Development Permit Panel

Thursday, December 12, 2013

2. Development Permit 12-617455

3. Development Permit 13-643519

Sheet Title: ELEVATIONS BUILDING A

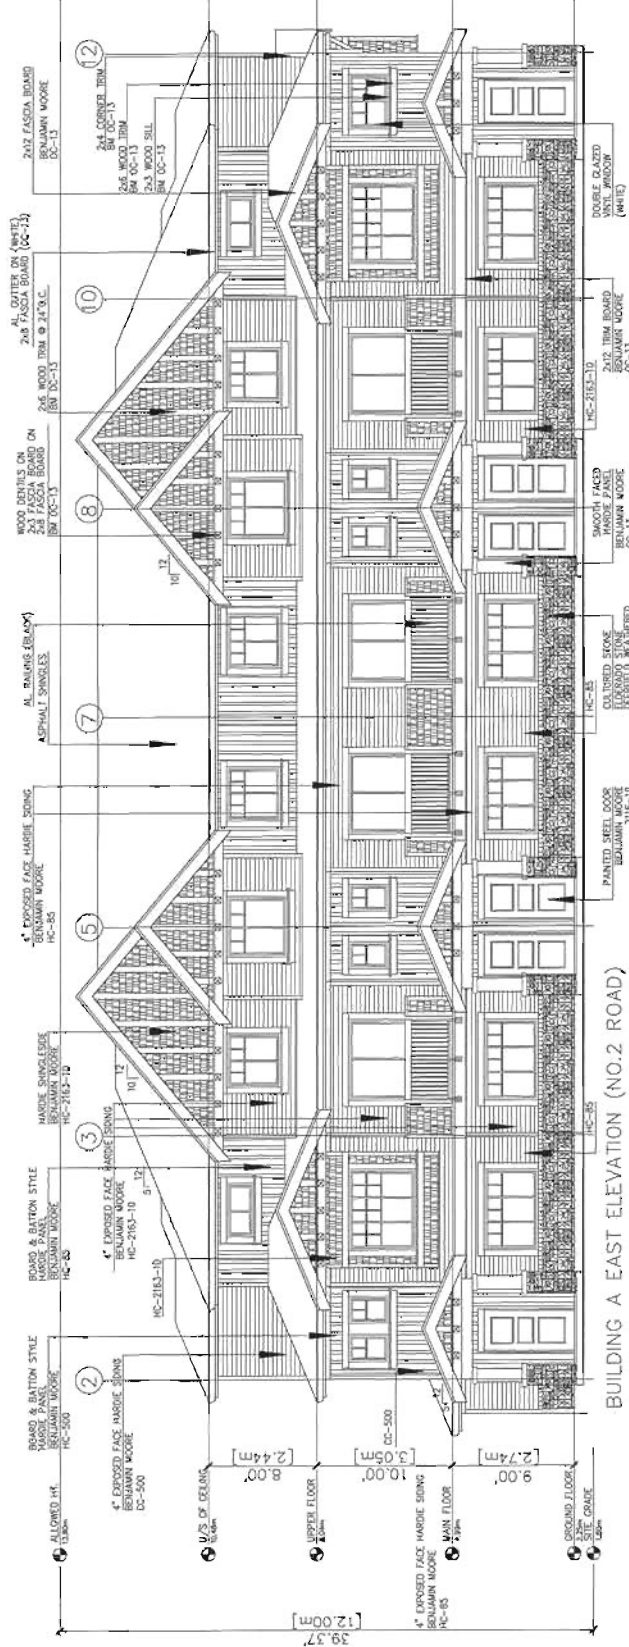
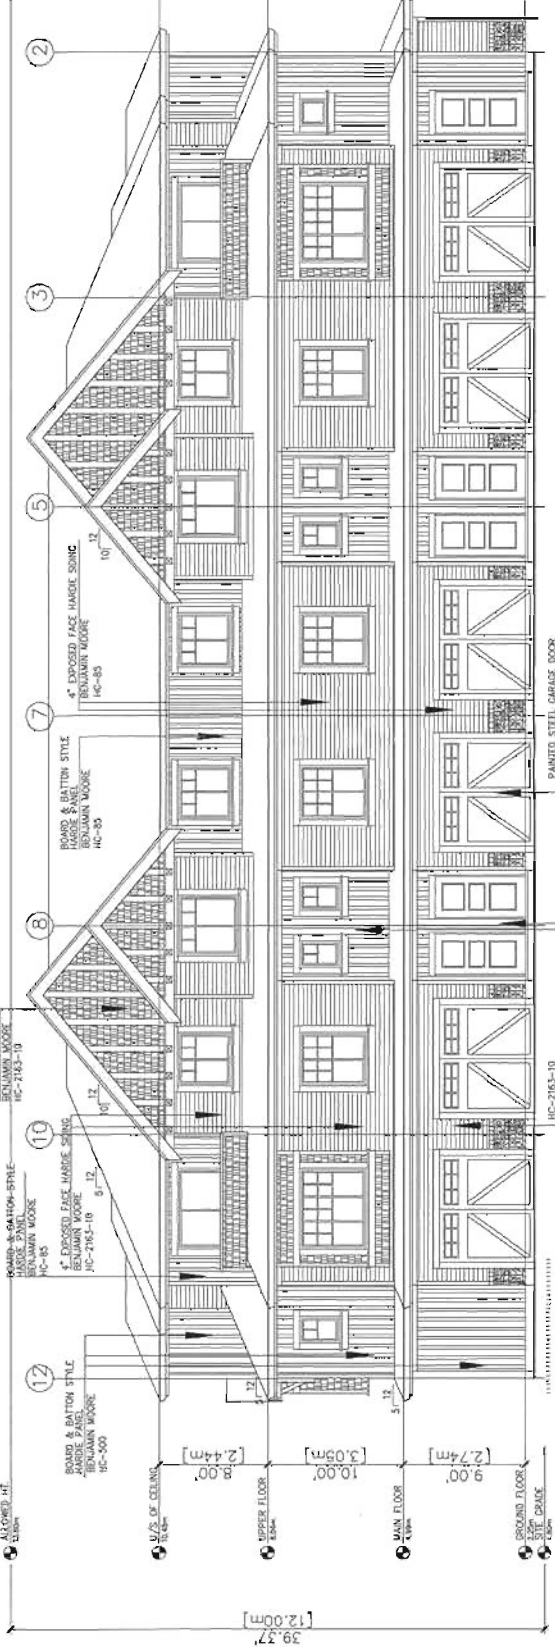
13. consider design development of units facing the interior driveway;
The north elevation of Building A and the south elevation of Building B have been revised with more windows and articulations.

16. elevations of the end units appear a bit austere; applicant could use some more glass;
The north and south elevations of Building A and B have been revised with more windows.

29. the north elevation of Building A and south elevation of Building B appear blank; consider adding at least a window near the turn to the internal drive aisle entrance to enhance the visual interest of motorists entering the project; and
The north and south elevations of Building A and B have been revised with more windows.

Sheet Title: ELEVATIONS BUILDING B

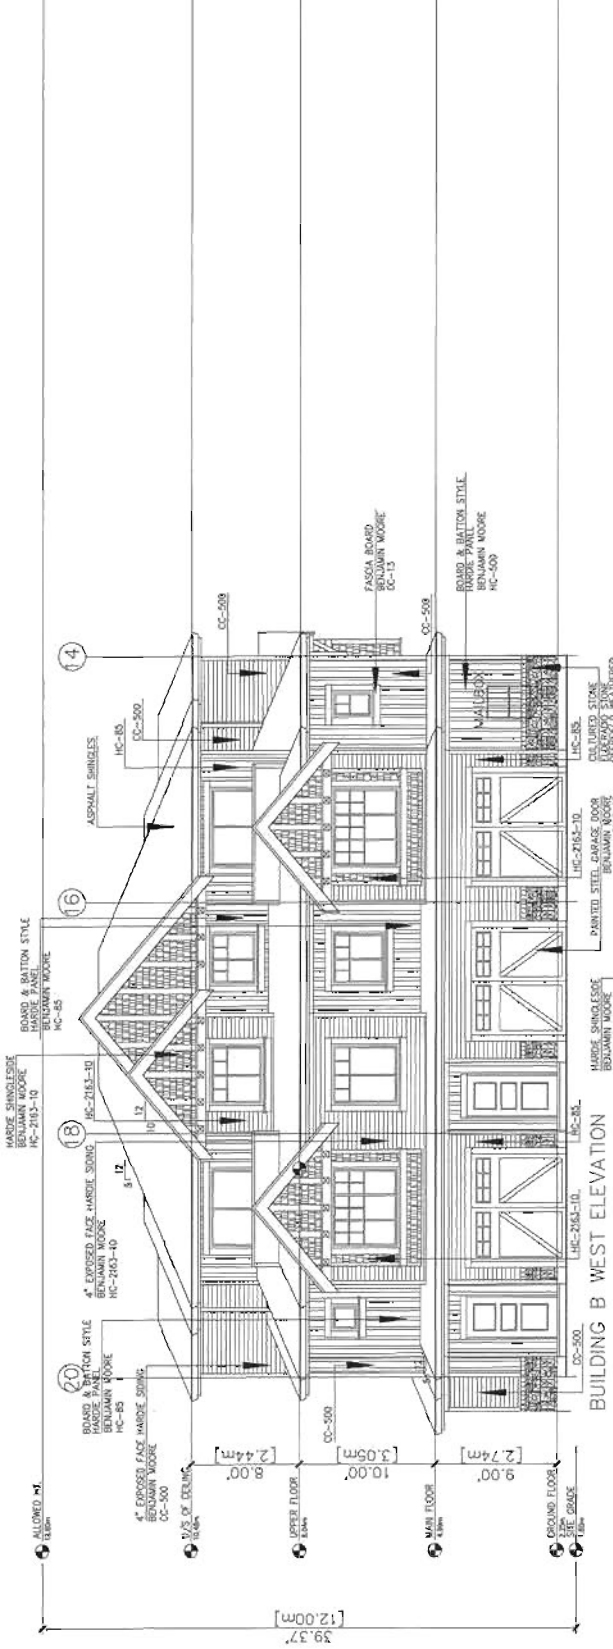
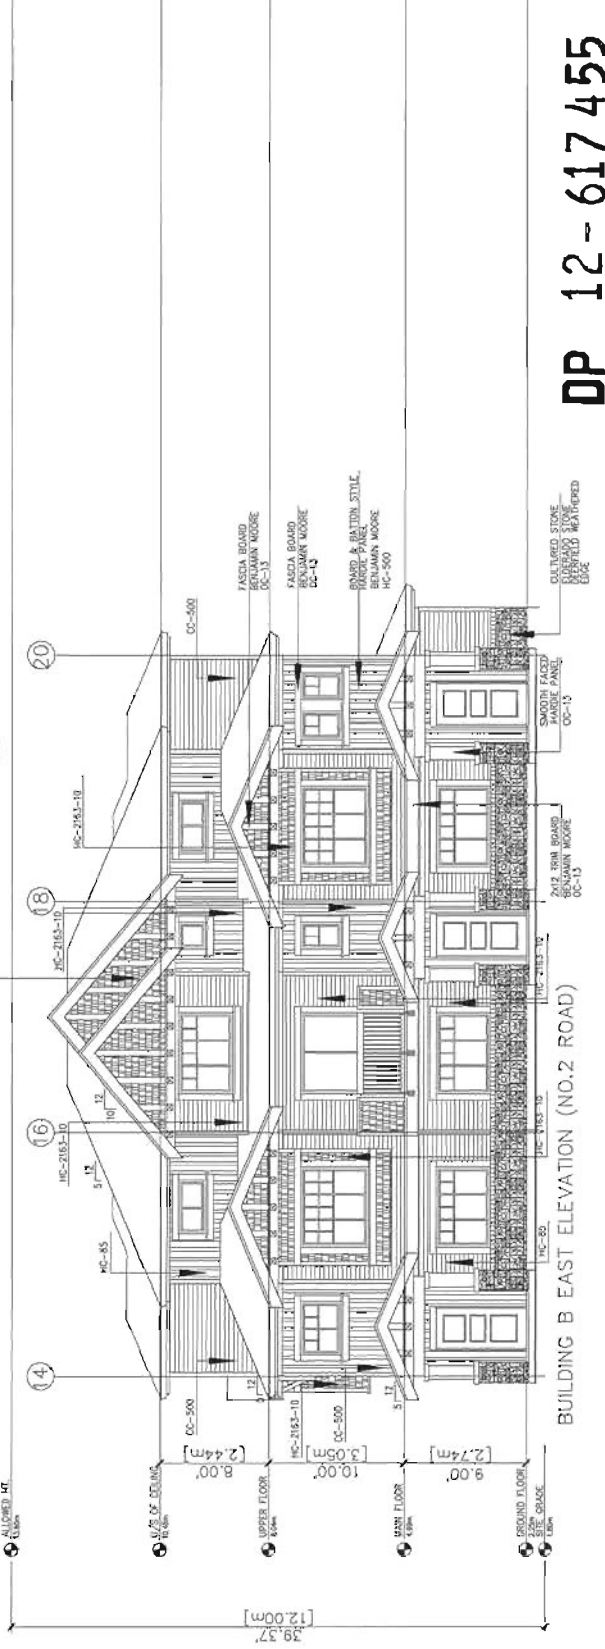
19. consider enhancing the treatment of ground floor units along the interior driveway;
The north and south elevations of Building A and B have been revised with more windows.

Sheet Title
FLOOR PLAN BUILDING D CONVERTIBLE UNIT

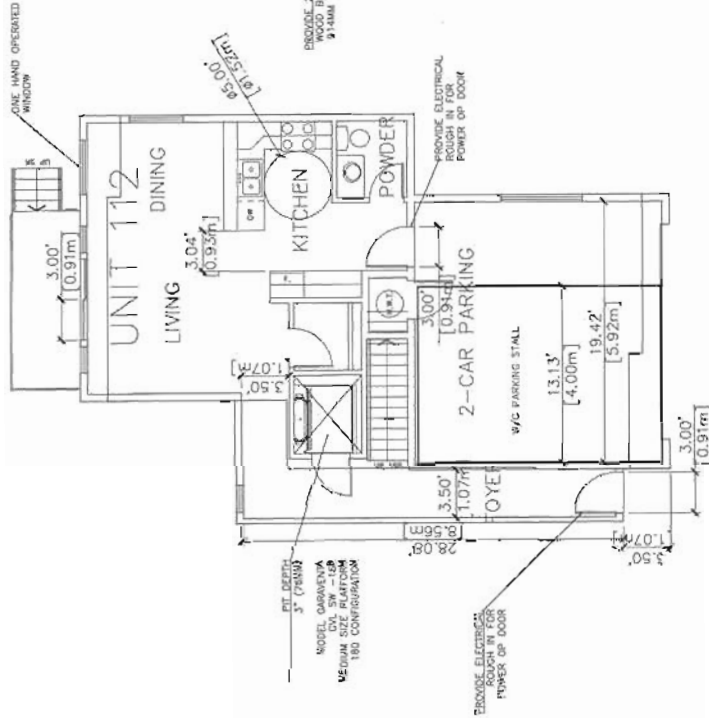
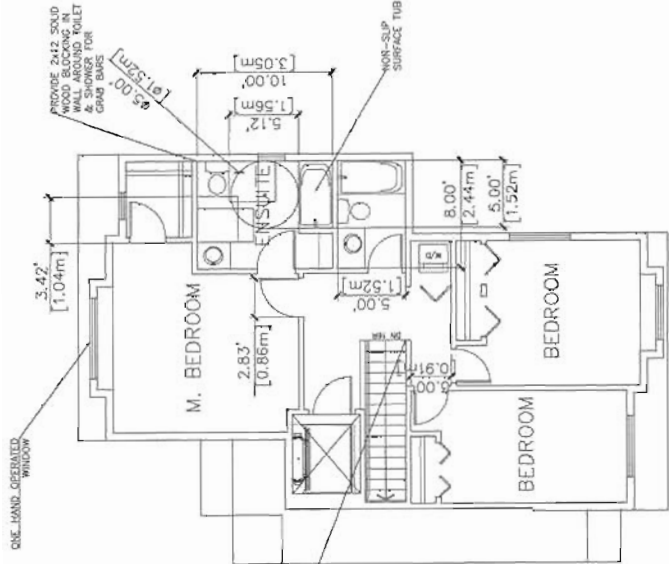
5. appreciate the provision of detailed drawings for the convertible unit; suggest that a sliding door be used in the powder room on the main floor to make it more usable; consider removing extra hallway space on the upper floor to create bigger bedrooms and a usable second washroom;
Noted. The convertible unit floor plans have been revised. See attached floor plans.
